PRODUCT/PROCESS CHANGE NOTICE (PCN)

ATTACHMENT 1 - PCN # : TB1601-01

PCN Type: Manufacturing Site - Alternate Test & Backend Location

TITLE: NA/NAG 100 & NH/NHG 100
 CARRIER TAPE (PCT)

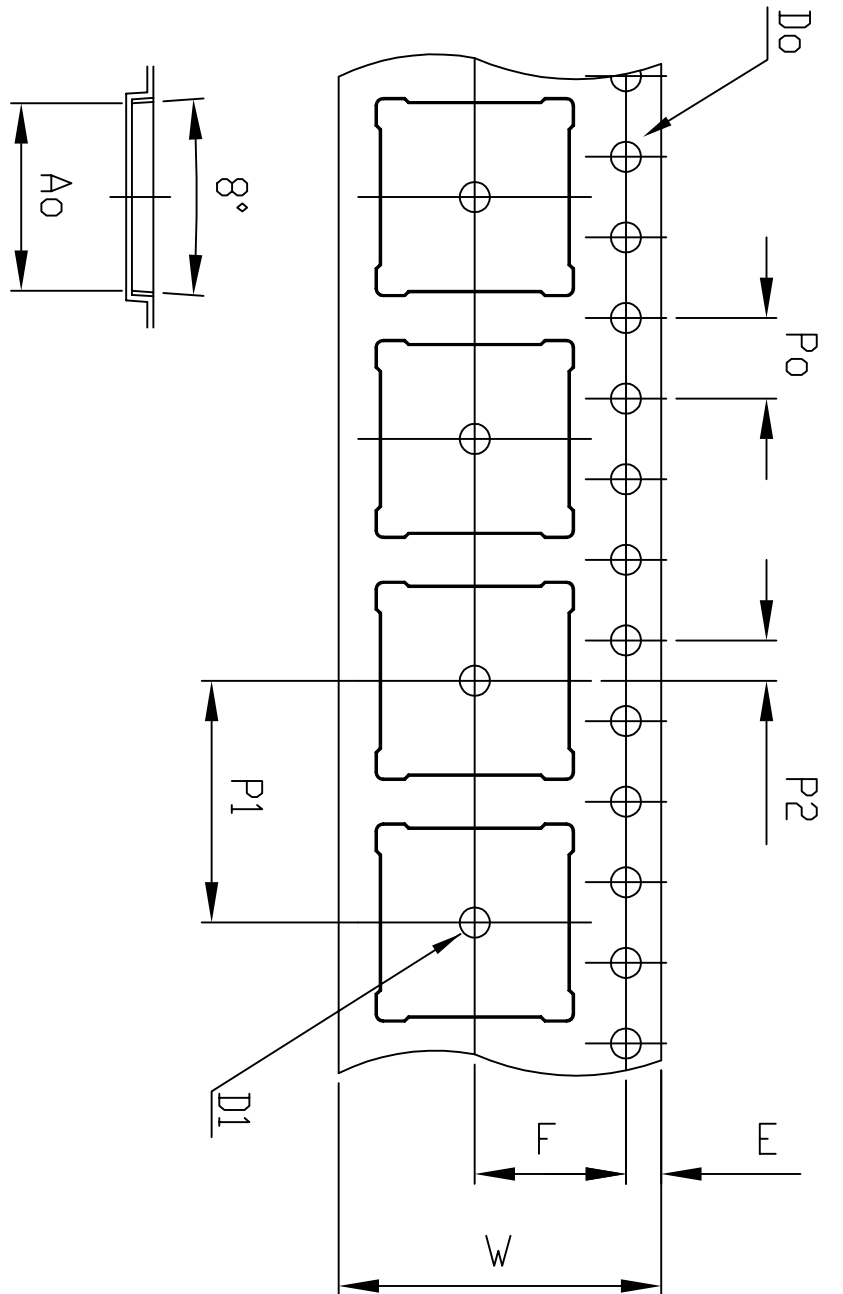
Item	Vendor	Carrier Dimensions		Cavity Dimensions (mm) ±0.1 or Specific				Top View	Drawing
		W (mm.) ±0.3	P1 (mm.) ±0.1	A0	B0	K0	K1		
IDT	PCT QFN9x9GP-20B3-360C-SD	16	12	9.3	9.3	1.05	NA		Refer Attachment 3
Sigurd	ADVANTEK ML0909-D	16	12	9.3	9.3	1.05	NA		Refer Attachment 4

Attachment 4 - Carrier Tape used by Sigurd

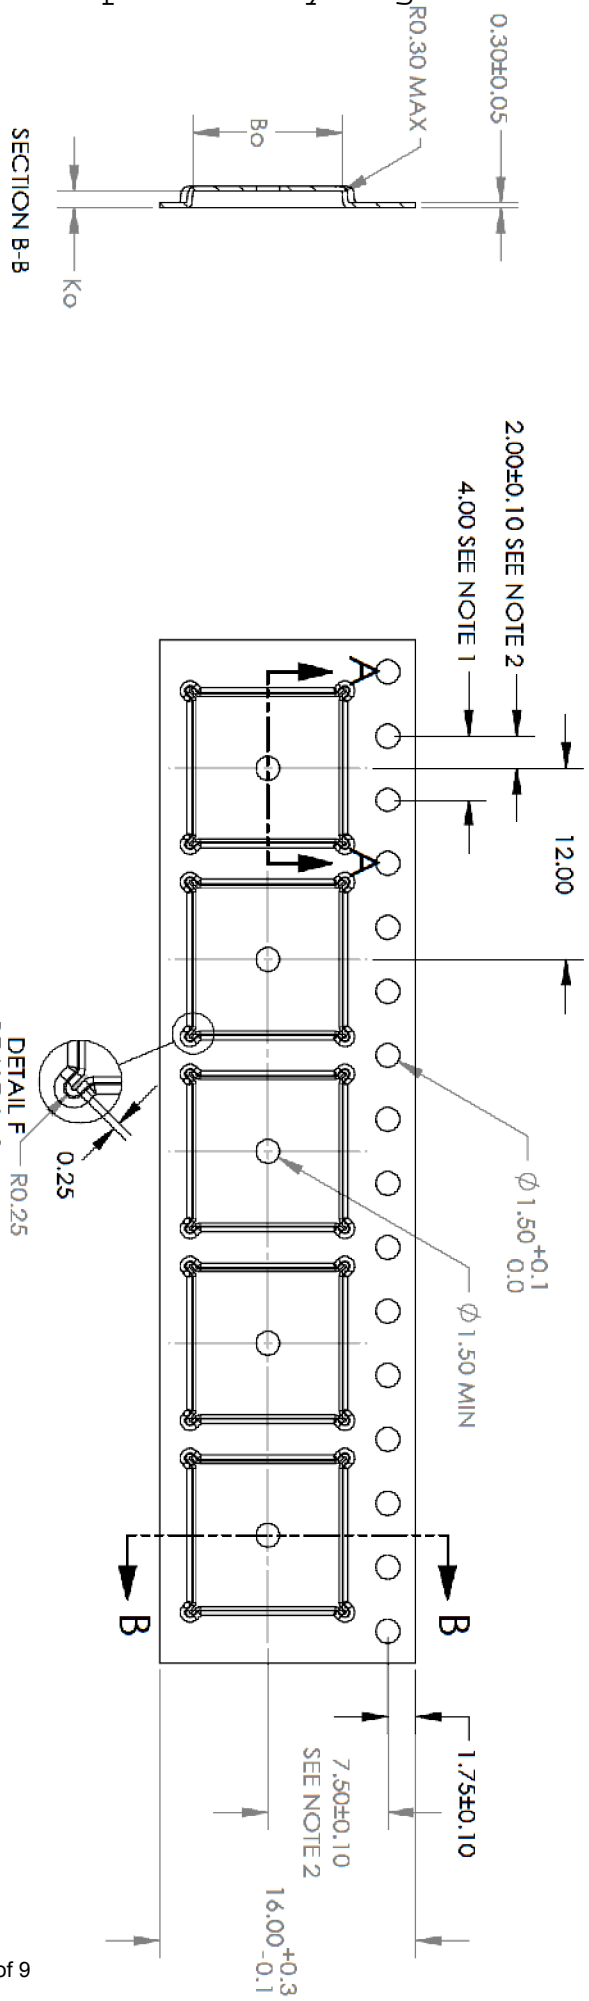
Carrier Tape and Plastic Reel comparisons:
